REMARKS

IN THE DRAWINGS

Amend the drawings as shown on the attached amended drawings ("Replacement Sheets") pages 1-3 to include the numerals 67, 68 and 78 where indicated.

FIG. 1

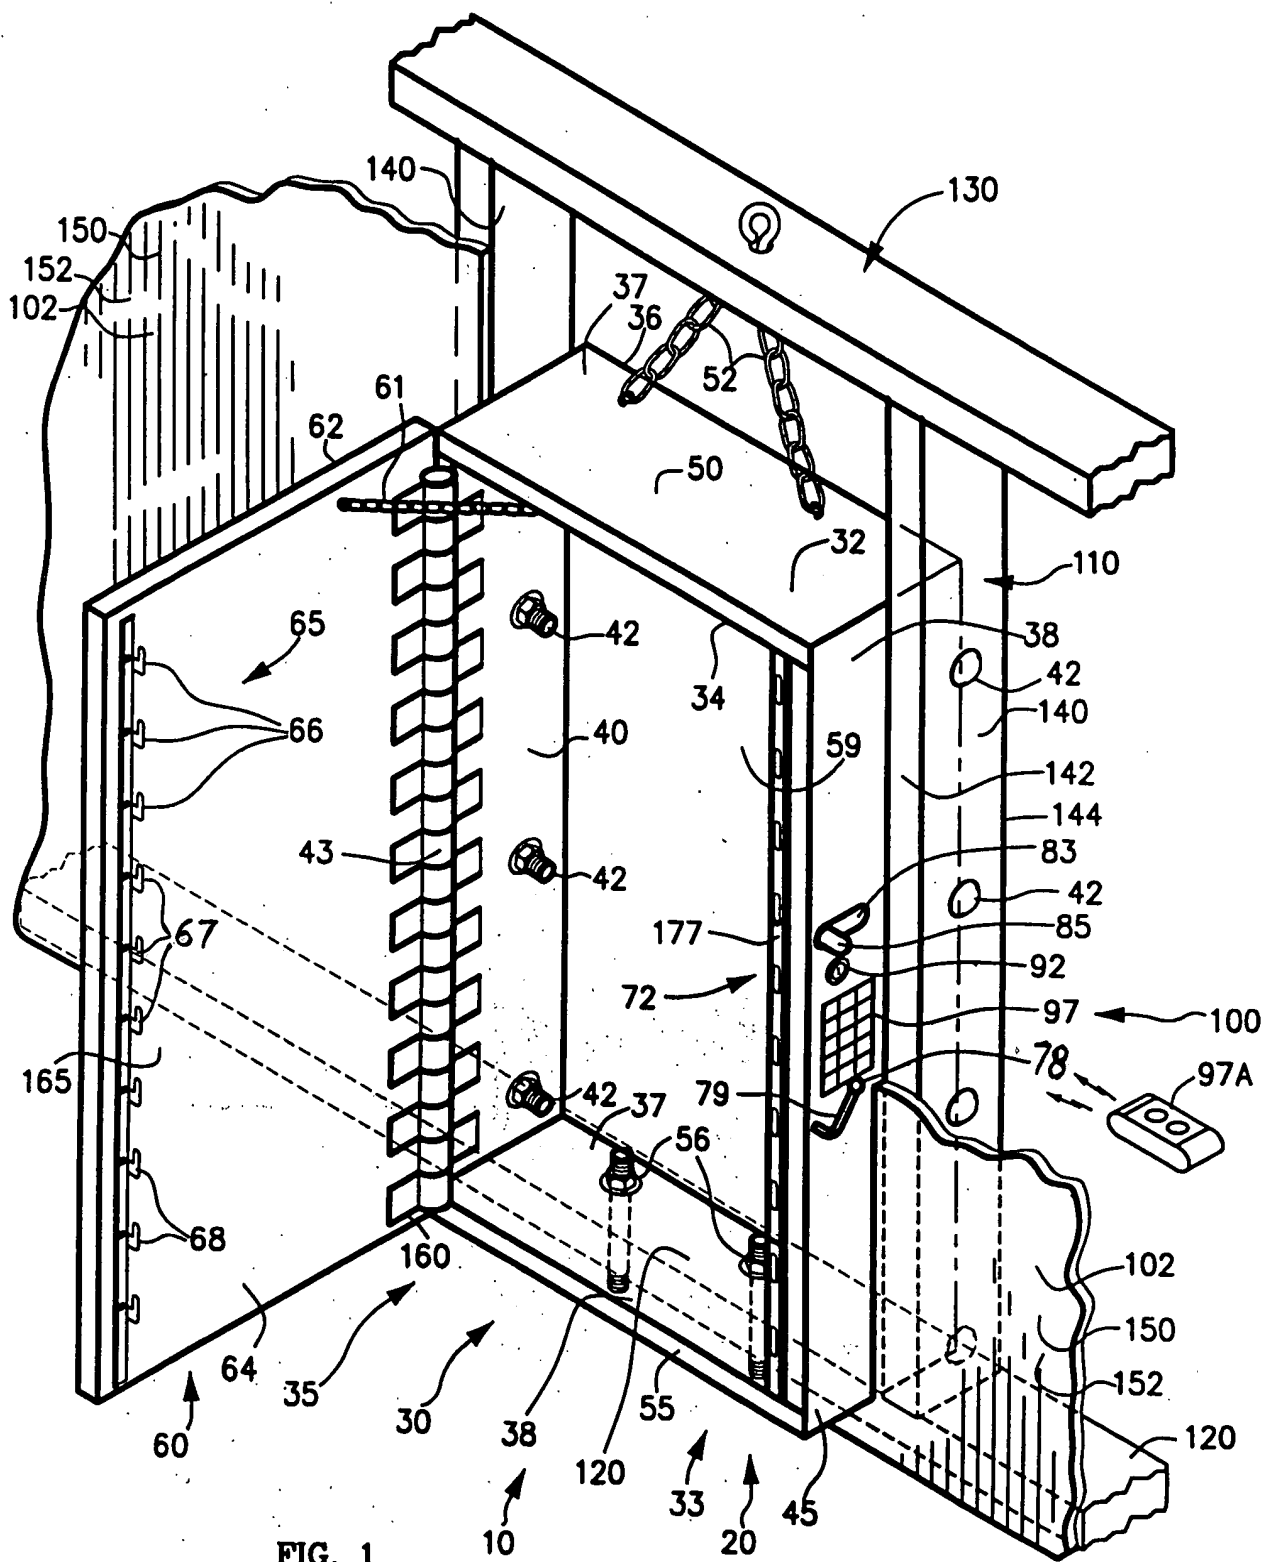
The drawings were objected to as not including the numerals 67 and 78 as mentioned in the Description. The drawings have been amended as shown on the attached amended drawings to include the numeral 67 for "catch means" in Figures 1 and 3 and to include the numeral 78 for "latch plate moving means" in Figures 1, 2, 5, and 6. Figure 3 has been amended to further include the numeral 68 for "catch" added clarity.
